Intersection ID: 2491	Main Street: LYNNEWOOD_GLEN_DR	Cross Street: MCCHESENEY_DR	Location:	NW
ADA ID: 7CC27AD23952	Ramp Type: Perp	Initial Pass/Fail: Fail	Overall Compliance: No	Severity Score: 21.25

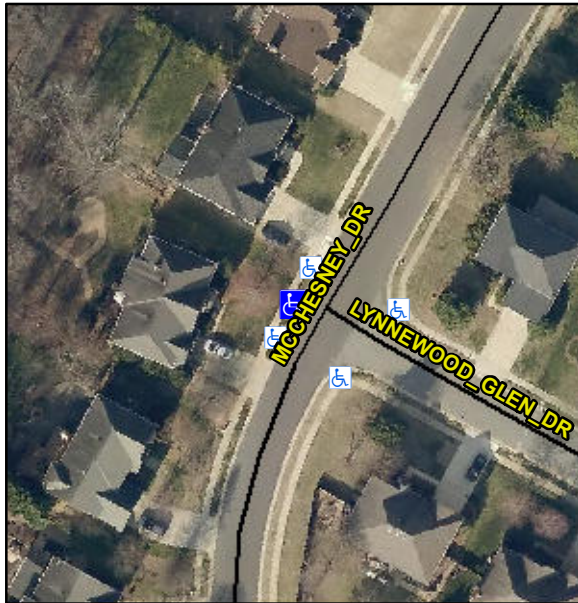
**Not Found, R304.5.1, R304.2.2**

Compliance	Description	Data	Compliance	Description	Data
N/A	Ramp Length (in)	47.0	No	Ramp Slope (%)	9.6
No	Ramp Width (in)	45.0	Yes	Ramp XSlope (%)	0.4
N/A	Flare Type LT	N/A	N/A	Flare Type RT	N/A
N/A	Flare Slope LT (%)	N/A	N/A	Flare Slope RT (%)	N/A
N/A	Flare Traversable LT?	N/A	N/A	Flare Traversable RT?	N/A
N/A	Landing Length (in)	N/A	N/A	DWS Provided?	N/A
N/A	Landing Width (in)	N/A	N/A	DWS Contrast?	N/A
N/A	Landing Slope (%)	N/A	N/A	DWS Length (in)	N/A
N/A	Landing X Slope (%)	N/A	N/A	DWS Full Width?	N/A
N/A	Landing Curb? (Y/N)	N/A	N/A	DWS Offset (in)	N/A
N/A	Shared Landing?	N/A			
N/A	Gutter Ponding?	N/A	N/A	Gutter Slope (%)	N/A
N/A	Gutter Lip Ht (in)	2.0	N/A	Gutter X Slope (%)	N/A
N/A	Painted X Walk1?	No	N/A	Painted X Walk2?	N/A
	X Walk 1 Direction	To SE		X Walk 2 Direction	N/A
N/A	X Walk 1 Width (in)	N/A	N/A	X Walk 2 Width (in)	N/A
	X Walk 1 Slope (%)	2.1		X Walk 2 Slope (%)	N/A
	X Walk 1 X Slope (%)	0.7		X Walk 2 X Slope (%)	N/A

### Remove & Replace Entire Ramp.
